SERVICE BULLETIN

No. Q89 under BRAKES

BRAKE IMPROVEMENTS

(All with Stopmaster II 15 x 7 Wedge Brakes)

FIGURE 1
ADJUSTING BOLT AND ACTUATOR

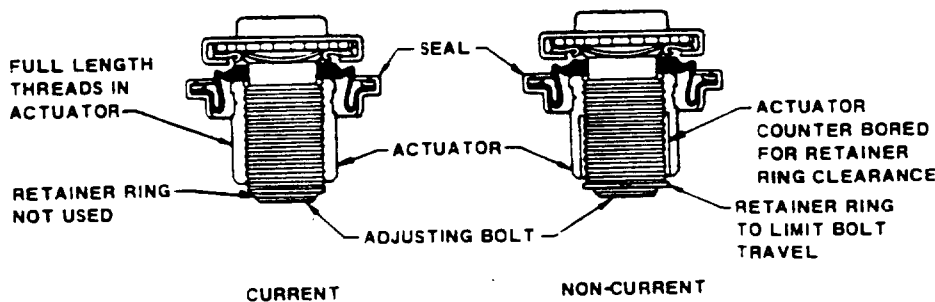
INFORMATION Early production of Stopmaster II brake assemblies had a limited travel adjusting bolt. These brakes reach their maximum adjustment before the lining is worn to the rivet heads. A new adjusting bolt is used in current production brake assemblies that permits additional lining wear. This bolt does not have the retainer ring to serve as a stop, thereby allowing full length of the bolt for adjustment. A new actuator is required with this bolt. See Figure 1 for details of this change.

Interchangeability of these parts is affected. The new adjusting bolt cannot be used with the old actuator. However, the old adjusting bolt can be used with the new actuator if the retainer ring is discarded.

FIGURE 2

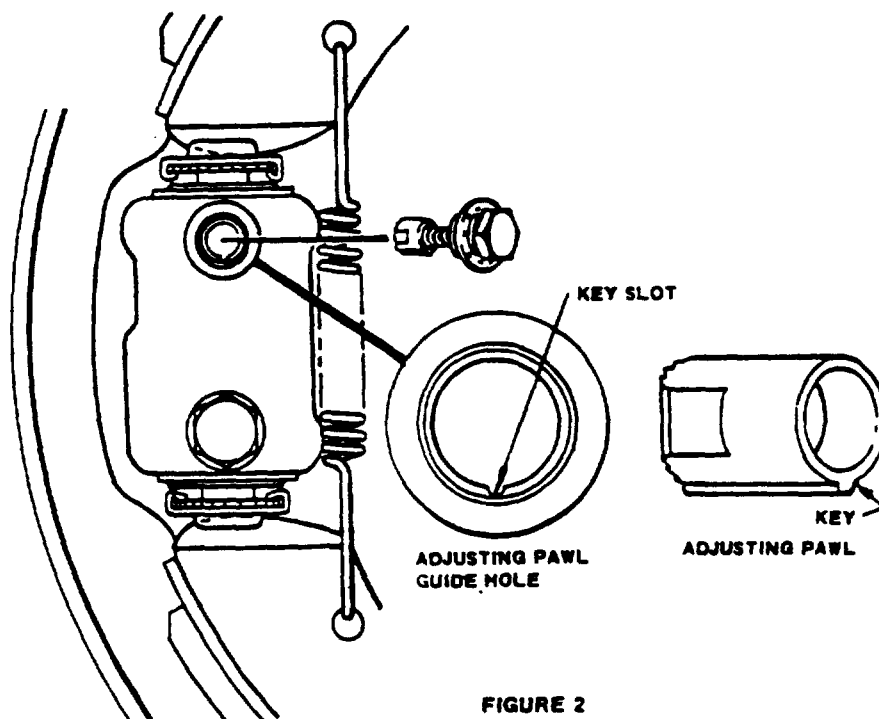
Stopmaster II assemblies can be identified by the slotted adjusting pawl guide hole and keyed adjusting pawl as shown in Figure 2. Late production assemblies also have the designation 'STOPMASTER II' stamped on dust shield.
